# Zoning Challenge and Appeal Form

BIS Job Number 122887224

Street Name Amsterdam Avenue

RE: Zoning Challenge 200 Amsterdam  
Block 1158, Lot: 133, Job No:  
122887224, Doc. 7

*Areas covered by the 1987 zoning lot classified by use of land (with 200 Amsterdam shown as constructed).  
Gerrymandered zoning lot of 200 Amsterdam and 200 West End Avenue shown in red*

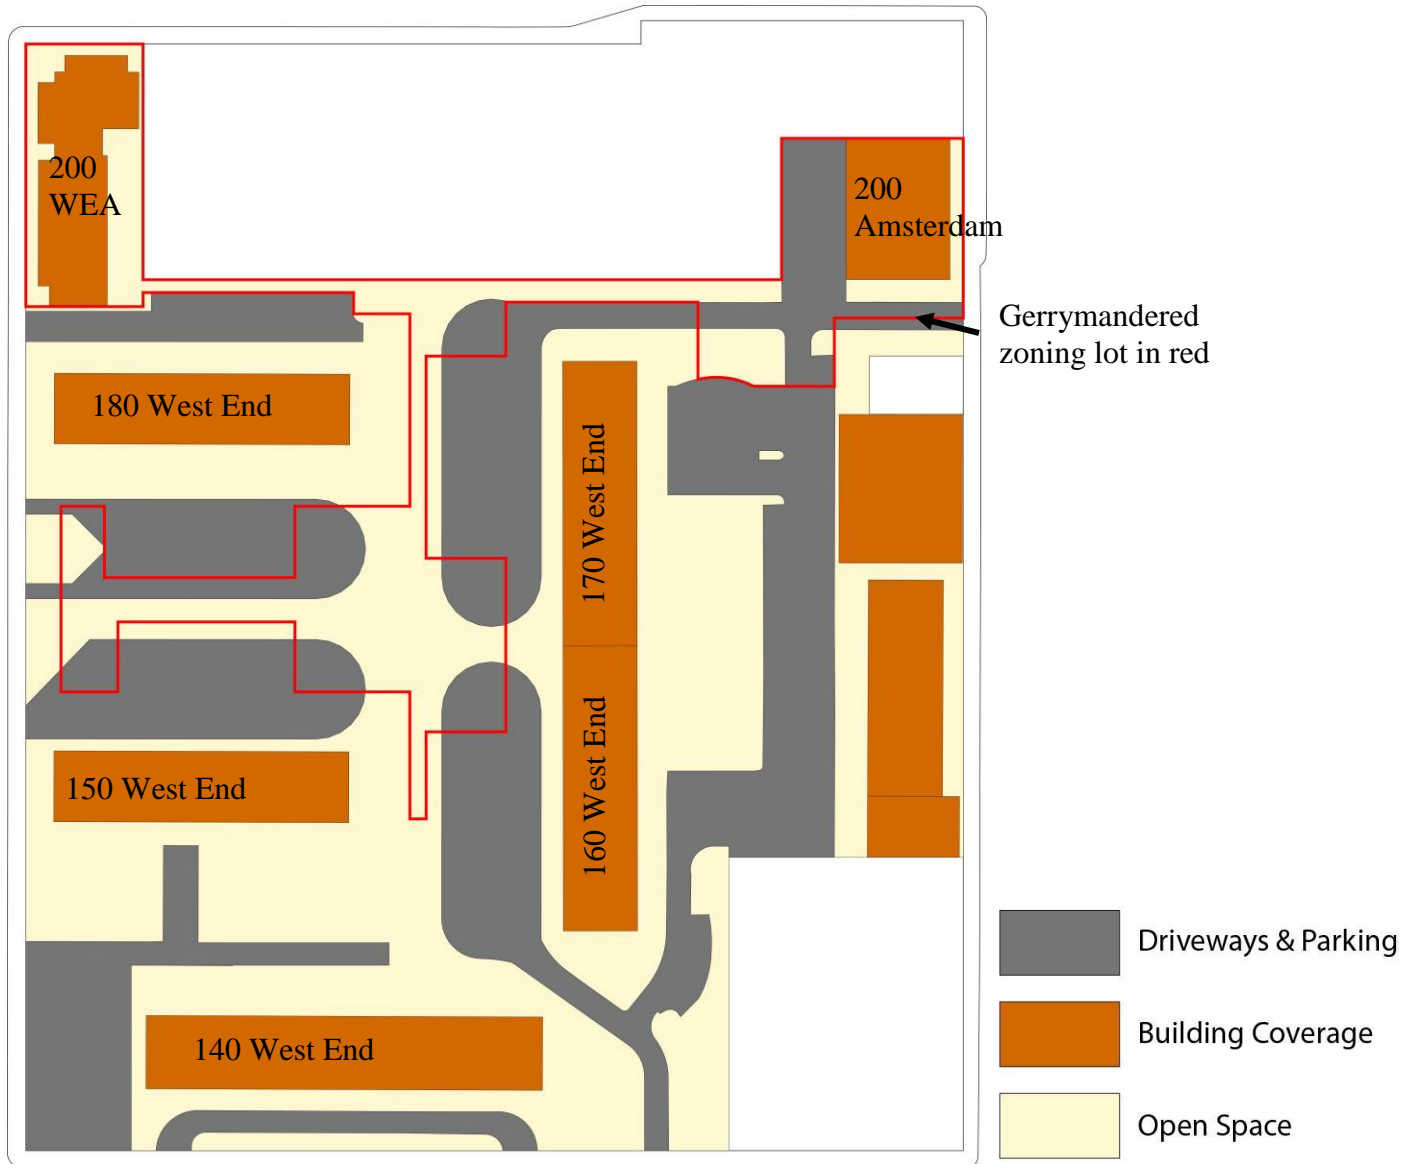
As stated in the Zoning Resolution, up to 50% of the required open space may be accessory parking, driveways, loading docks and bike parking. These uses are shown in gray above.

By my office's calculations, 33,983 SF of the open space on the gerrymandered lot is used for driveways and parking. According to 12-10, an Accessory use:

The parking and driveways are accessory to the uses on the Lincoln Towers zoning lot. They are not accessory to the uses on the gerrymandered lot since there is no parking provided for 200 Amsterdam or 200 West End Avenue. Uses accessory to another zoning lot are not permitted obstructions in Open Space, and thus, the 33,983 SF cannot be counted as open space in 200 Amsterdam's zoning calculations.

The building still complies according to FAR, but has nowhere near enough open space. At 8.7, the required Open Space ratio is 4.7 points too low, which is an *enormous* amount of open space considering the size of the development. I acknowledge that the measurements and the delineation of the parking areas was done from aerial photographs, and a survey of these areas could result in different measurements. But the amount of difference conceivable from a survey would not change this level of non-compliance: about 80% of the area now used as parking and driveways accessory to Lincoln Towers would have to be reclassified to complying open space for 200 Amsterdam to even approach compliance with the required open space ratio.

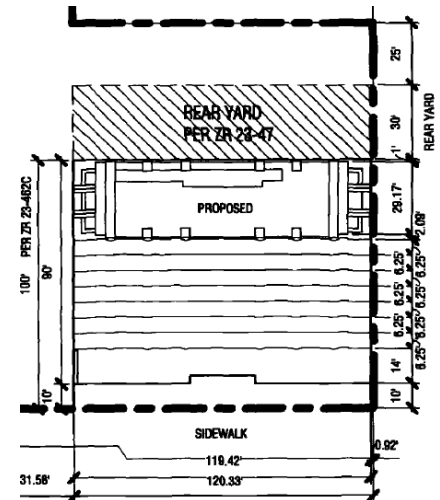
The proposed rear yard of 200 Amsterdam from the ZD1 is shown to the right. It is used as parking that is accessory to Lincoln Towers. As was stated earlier in this letter, an accessory use, “is a use conducted on the same zoning lot as the principal use to which it is related.” Consequently, the proposed rear yard does not comply with 23-44.

*The sky exposure plane proposed for 200 Amsterdam. The top four floors break the sky exposure plane.*

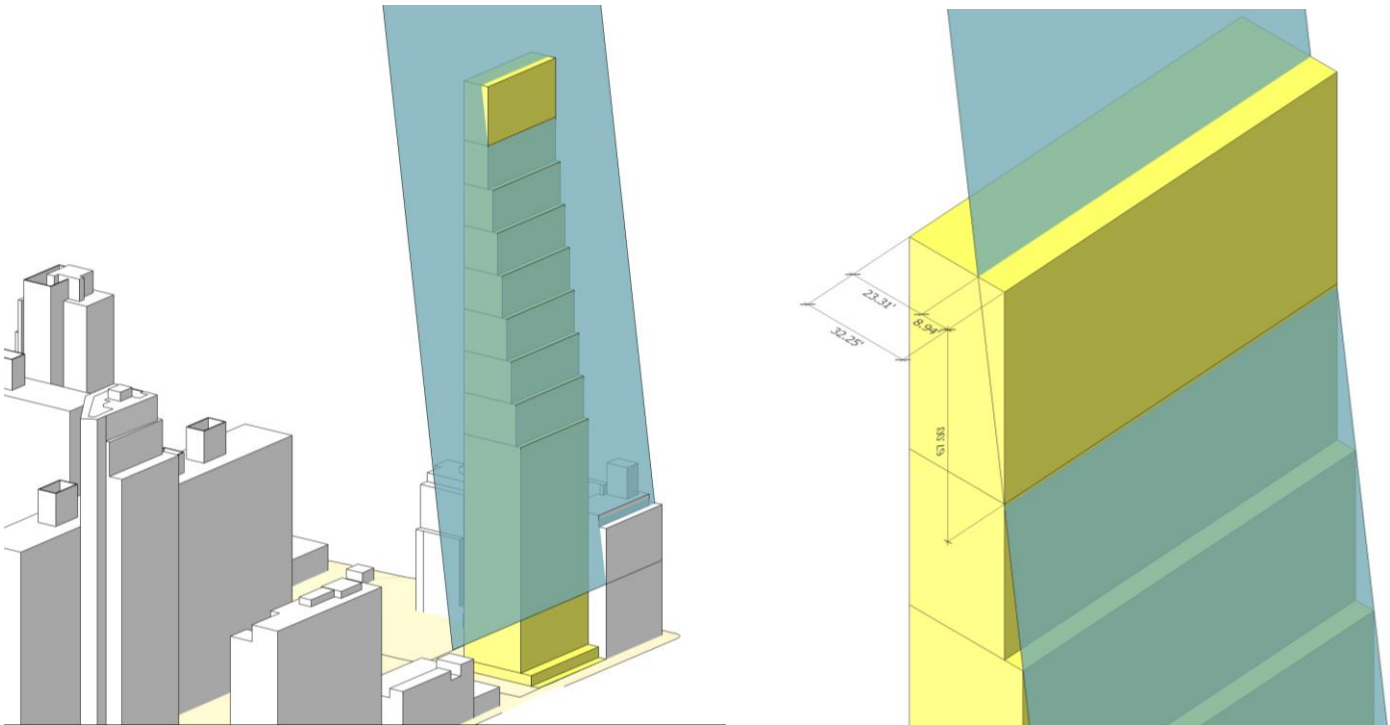
The top four floors of the building contain building mechanicals. No mechanicals are placed on the roof. The ZD1 shows that these four floors pierce the sky exposure plane, treating them as a permitted obstruction.

The ZD1 states, in effect, that the mechanical equipment located in floors 51 through 55 are permitted obstructions under 23-62(g). The question as to if the in-building mechanical floors may penetrate the sky exposure plane as a permitted obstruction hangs on the definition of “enclosures.” Unfortunately, this is not a defined term in the Zoning Resolution, but the applicant claims, and the Department has agreed, that enclosures may mean exterior building walls. This interpretation is in error, however, as it is not consistent with the New York State Multiple Dwelling Law (MDL).

While it is not a defined term in the MDL, the expression “superstructure” is used here, and elsewhere in the MDL, to refer to a structure that is on top of a building. The obvious interpretation of the MDL is that building height is measured to the top of the roof, with fairly wide exceptions for rooftop mechanicals, parapet walls and the like. The less obvious--and I would say incorrect interpretation--is that the first 50 feet of mechanicals can be exempted from building height. Either way, at 67 feet, the top four mechanical floors break the prescribed sky exposure and should not be considered permitted obstructions to maintain consistency with the MDL, as required by law.
